Energy Metals Corporation
Responses to NRC Request For Additional Information
Moore Ranch Uranium Project Source Material License Application

Figure E-1.f(1) Production and Restoration Sequence, Ingaray Mine Units 1 through 9

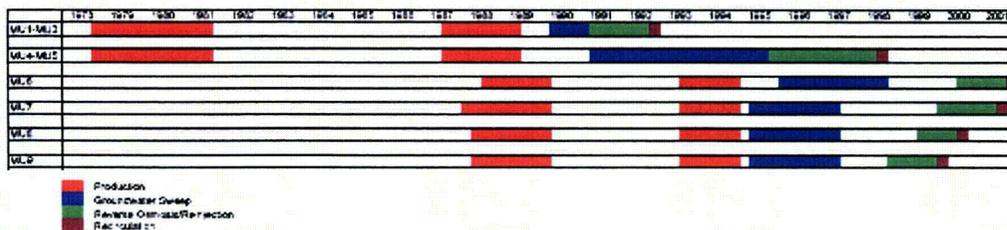
- f. Justify in detail the six pore volumes estimate for each of the wellfields, which appears very low, using a basis of comparable field experience or revise the estimate. Reported field case pore volumes from the similarly situated COGEMA Irigaray ISL Units 1-9 ranged from 9.5 to 18.4 with an average of 14.6 to achieve restoration. If the applicant retains the estimate of six pore volumes, it should provide a substantial justification using analytical methods or numerical modeling. These estimates should also take into account unique issues presented by the

unconfined aquifer setting at Moore Ranch and address any difference in pore volumes needed if biological reductants are used. Provide a new schedule for restoration if the estimated number of pore volumes for restoration is revised. (See also RAI 6-6.)

Restoration was not performed immediately following the completion of production, and in some cases, there were long periods of inactivity during the production and restoration phases. At Irigaray, production was interrupted for a period of almost six years in MU1 through MU5 [Figure 6-1.f(1)]. Similarly, there was a three-year break in production in MU6 through MU9, when the operation was in standby status. Restoration did not commence at MU1 through MU3 until a year after production had ended. At MU4 and MU5, restoration operations did not begin until two years following production. Restoration commenced shortly after the end of production at MU6 through MU9. However the project was on standby status between the completion of groundwater sweep and the beginning of the RO phase of production, resulting in a break of one to two years, depending on the MU. Restoration was initiated sooner after the end of production at Christensen Ranch, with the exception of MU3 and MU4. However, there were periods of standby between groundwater sweep and RO treatment/injection of up to a year. These delays between and during production and restoration operations most likely increased the number of PVs required to complete aquifer restoration. Uranium One will commence restoration activities upon completion of production within a wellfield.
